Dear editor,

Abstract

Figure 2. Principal wave parameters presented on an idealized sine wave.

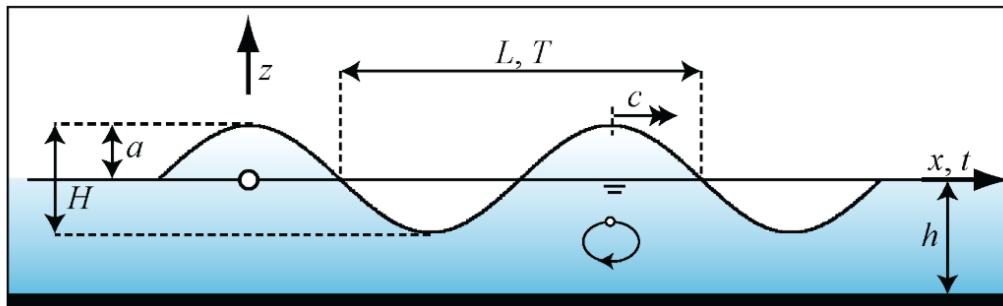
Line 19: Add “entering” before “into”, change the sentence “resulting in displacement wave amplitudes of up to 25.2 m” to “resulting in a displacement wave up to 25.2 m in height”.

Reply: Thank you for your tip. We made the change accordingly. But here we want to express the wave amplitude (the parameter “a” in Figure 2), not the wave height (the parameter “H” in Figure 2). Therefore, the sentence is correct as “resulting in a displacement wave up to 25.2 m in amplitude”.
